WESTERN ENERGY COMPANY - *Rosebud Mine*

April 28, 2020

Permit ID: C1984003B
Revision Type: Permit
Permitting Action: Deficiency Response
Subject: AM5; Round 5 Acceptability Deficiency Response

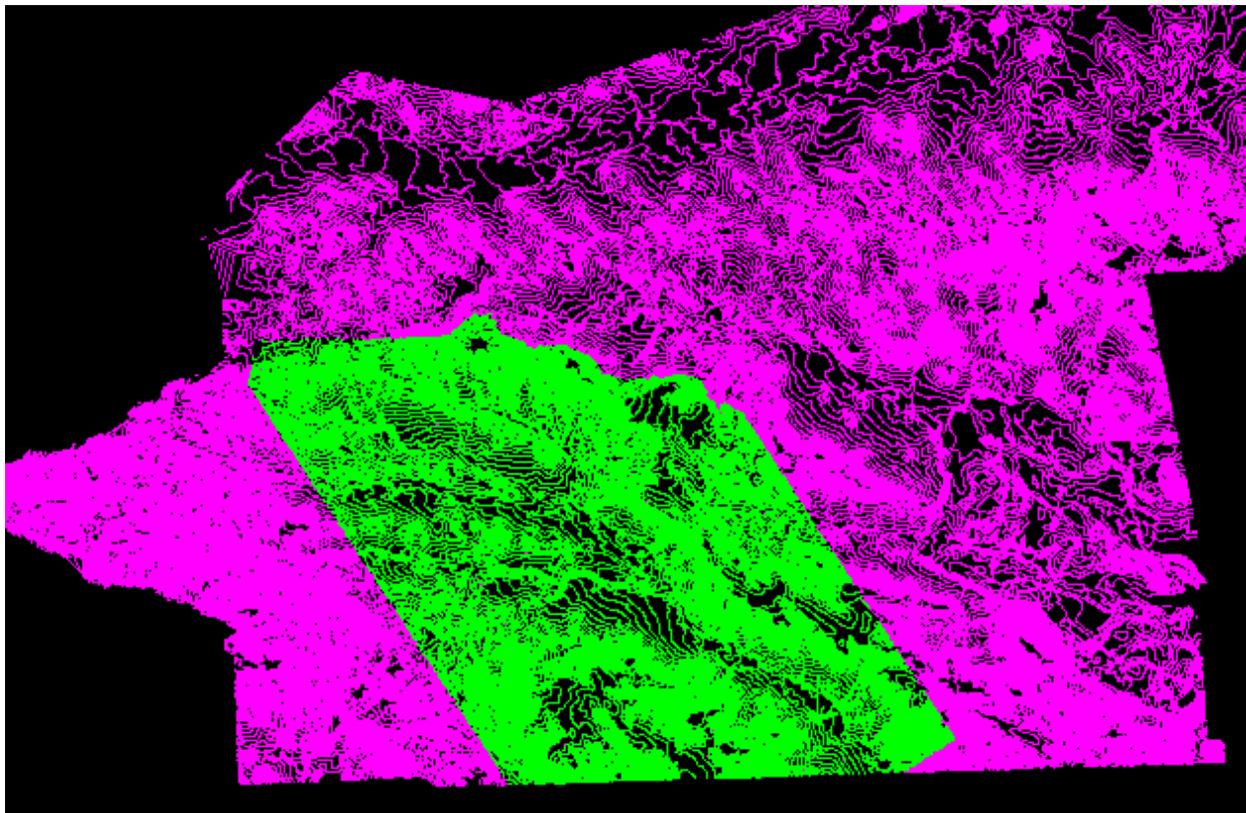
ARM 17.24.314(2)(a): DEQ cannot complete its review of drainage control for the Richard Haulroad in Section 28 until the design is updated for the premine topography.

ARM 17.24.321(1)(a): The Richard Haulroad Phase I is planned to be built prior to mining of the underlying coal in Cuts BXS92 and BXS93, however the design contours on "Area B AM5 EXHIBIT O Richard Haulroad Phase I Sheet 1 of 3 2019-10.pdf" appear to be based on the PMT. The portion of the road from approximately 125+00 to 200+00 must be redesigned based on the premine topography.

Response: After reviewing and overlaying the contour lines of Exhibit O Richard Haulroad Phase 1 Sheet 1 of 3 and Exhibit U Premine Topography, the topography matches. Please see the screenshot below. The magenta lines are the contours from Exhibit U and the green lines are the contours from Exhibit O. The design of the Richard Haulroad in Section 28 was submitted with the premine topography. Please see Exhibit O Richard Haulroad Phase I Sheet 1 of 3.pdf.

Response: After reviewing and overlaying the contour lines of Exhibit O Richard Haulroad Phase I Sheet 1 of 3 and Exhibit U Premine Topography, the topography matches. Please see the screenshot below. The magenta lines are the contours from Exhibit U and the green lines are the contours from Exhibit O. They match. The design of the Richard Haulroad in Section 28 was submitted with the premine topography. Please see Exhibit O Richard Haulroad Phase I Sheet 1 of 3.pdf.
